Application No.: 09/940,349

Docket No.: JCLA7911

REMARKS**Present Status of the Application**

FIG. 8 (PRIOR ART)

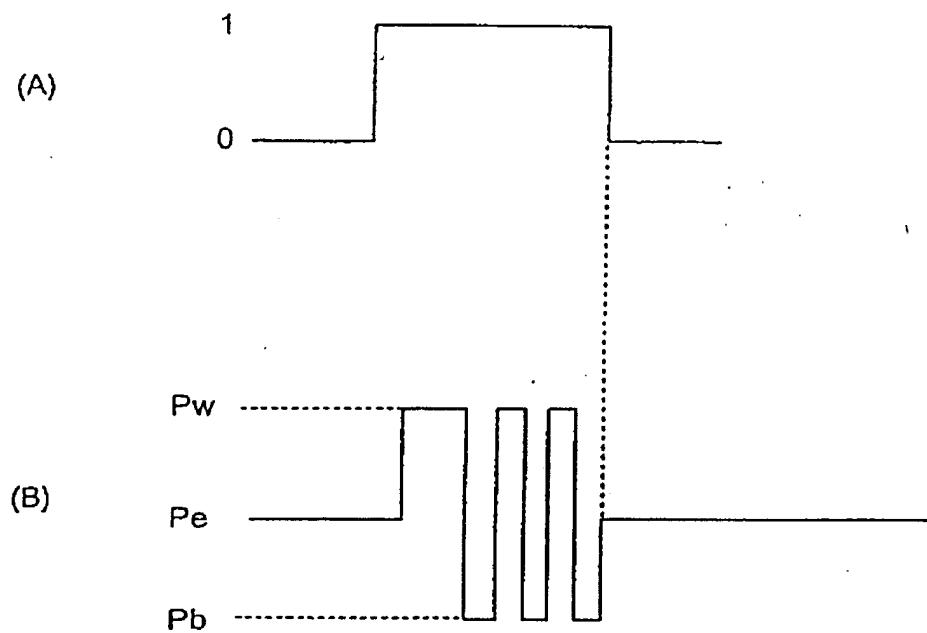
The Office Action mailed on April 7, 2004, rejected all claims 1-3. Specifically, the Office Action rejected claims 1-3 under 35 U.S.C. 102, as being anticipated by admitted prior art. The Office Action also objected to the drawing FIG. 8 because of failing to show "PRIOR ART". Applicants have amended independent claim 1 above, to overcome the rejections under 35 U.S.C. 102. As amended, these claims clearly distinguish the prior art, and therefore overcome the rejections under 35 U.S.C. 102. After entry of the foregoing amendments, claims 1-3 remain pending in the present application, and reconsideration of those claims is respectfully requested.

The drawing is objected to because FIG. 8 fails to show "PRIOR ART". Applicants have amended FIG. 8 to add "PRIOR ART". Therefore, this objection has been properly addressed and overcome.
